Environmental Impact Statement

Accelerator Production of Tritium at the Savannah River Site

**Final
March 1999**

TITLE: Final Environmental Impact Statement: Accelerator Production of Tritium at the Savannah River Site (DOE/EIS-0270)

Figure 4-15. Comparison of Baseline APT Footprint to Modular APT Footprint at the preferred site.

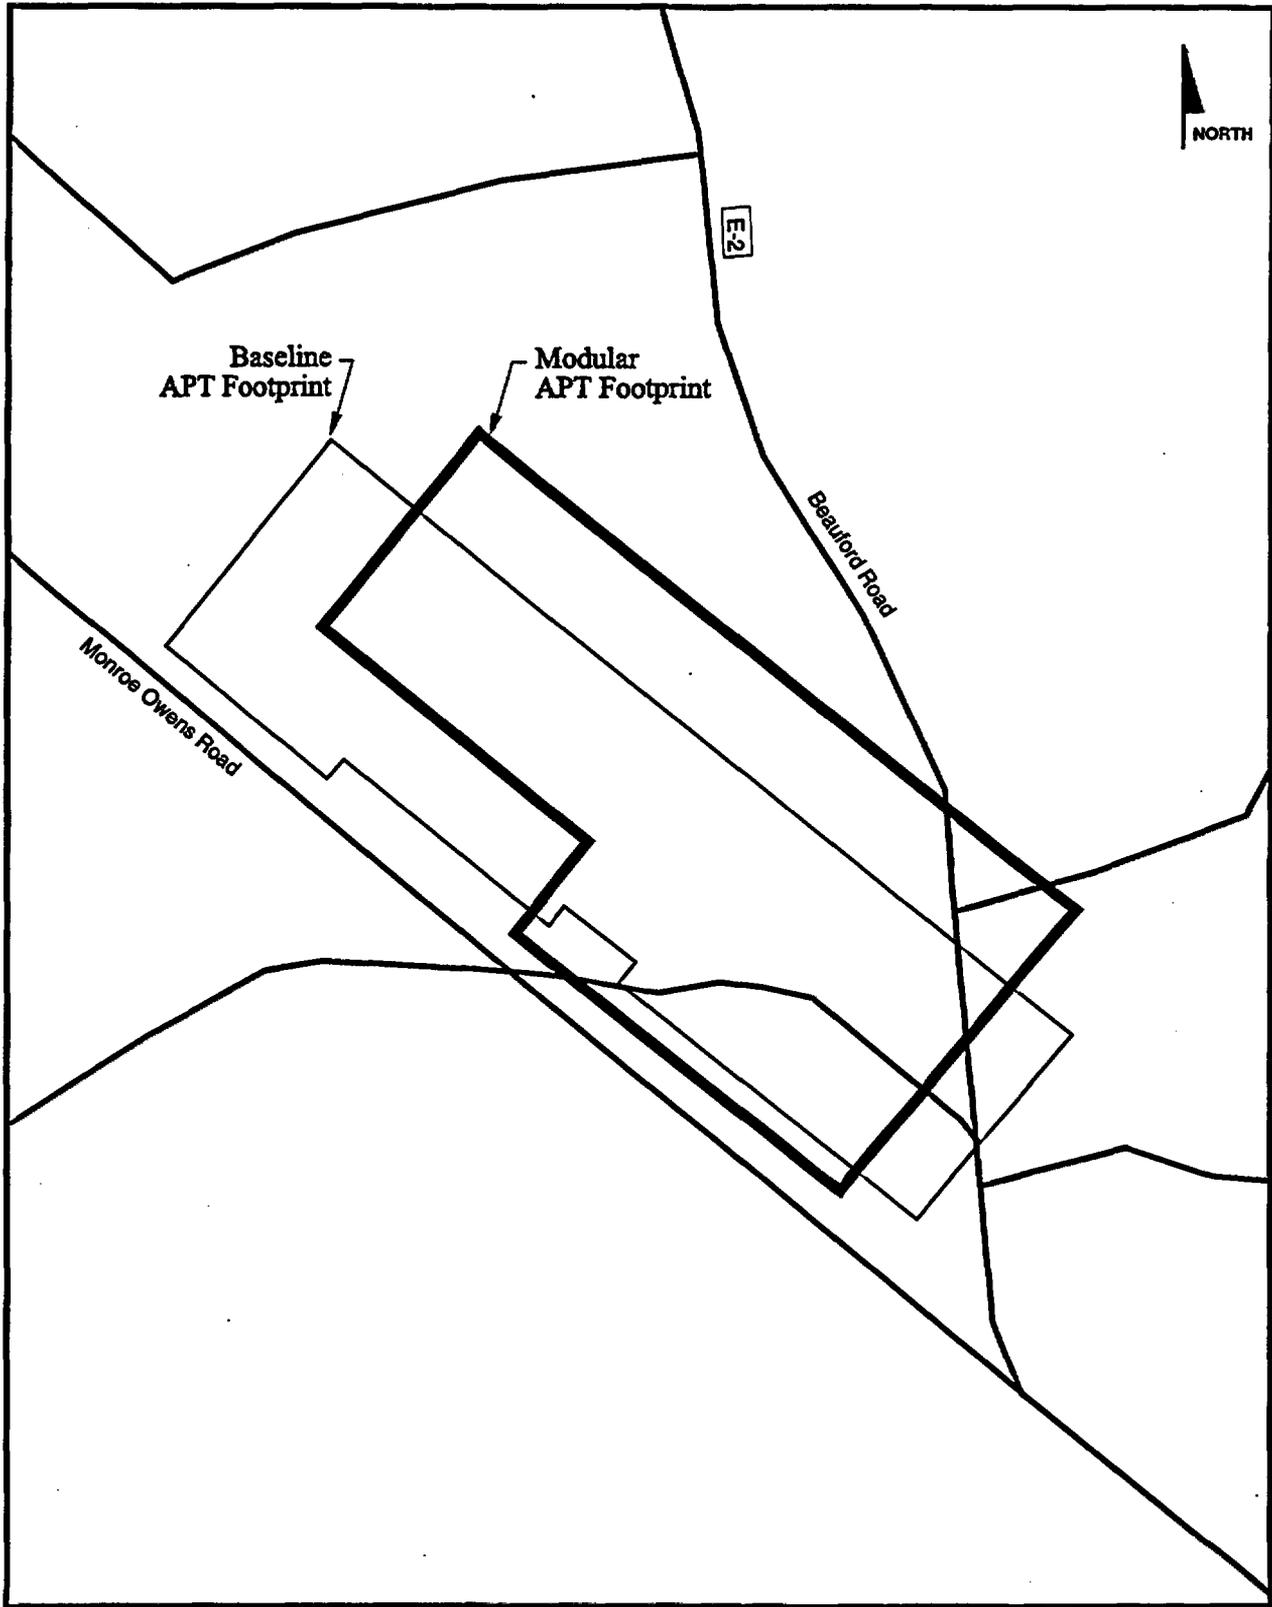
Differences from baseline APT: The layout of the buildings for the modular APT is somewhat different from the baseline APT (see Figures 4-15 and 4-16). The modular APT footprint would be slightly wider than the baseline footprint; however, the total area required would remain less than the 250 acres needed for the baseline footprint. This change in footprint shape brings into the APT site both soil and forest areas that were not described in the Draft APT EIS. These areas have the same characteristics as the areas previously described in the Draft EIS. The impacts would be the same as for the baseline APT.
